Town of Innisfil Building Dept Notes:

NIPISSING MODEL 3210

PROPOSED TWO STOREY DWELLING

FOR: LORMEL HOMES AT: INNISFIL

A-3

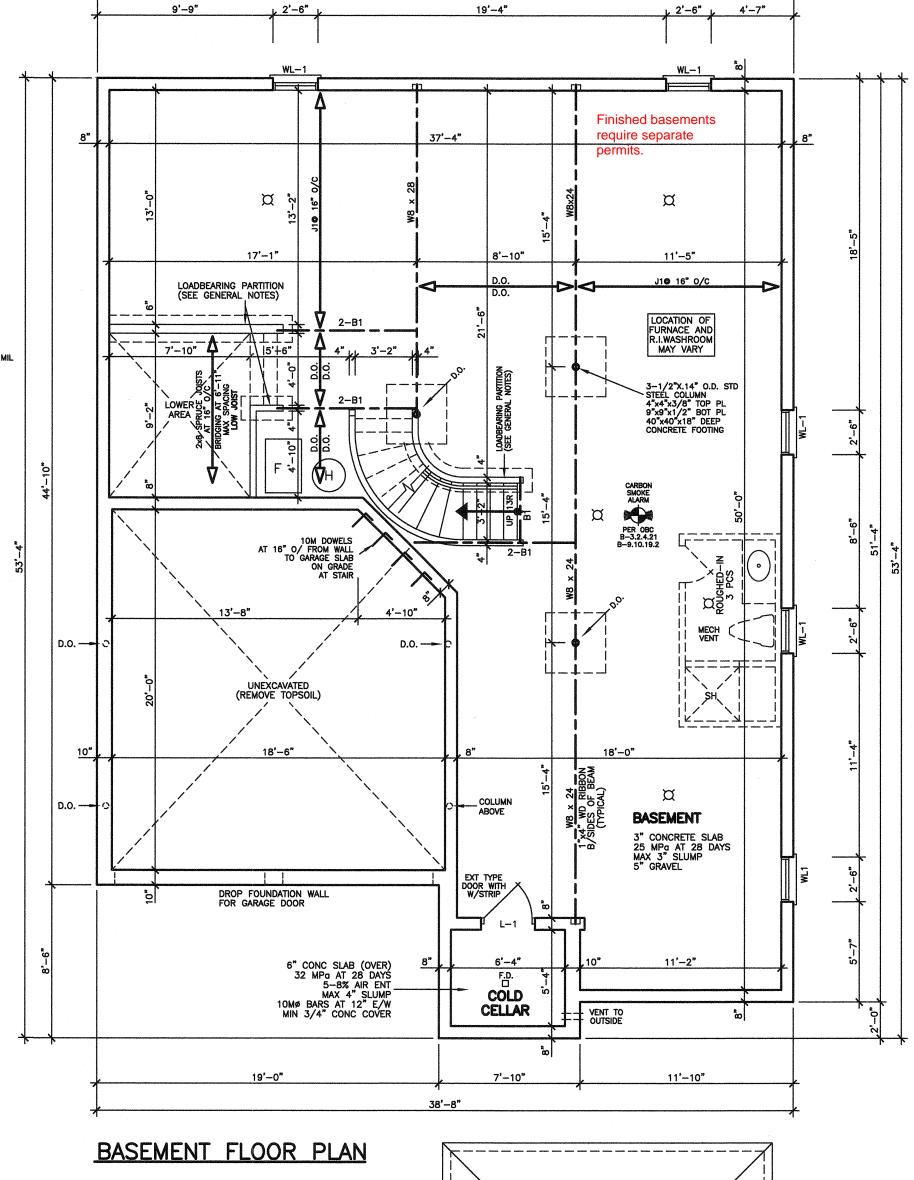
All smoke alarms and CO detectors shall comply with O.B.C 9.10.19 and 9.33.4

Main bathroom shall be designed as per 9.5.2

All construction subject to review by Town **Building Inspectors**

See comments on permit
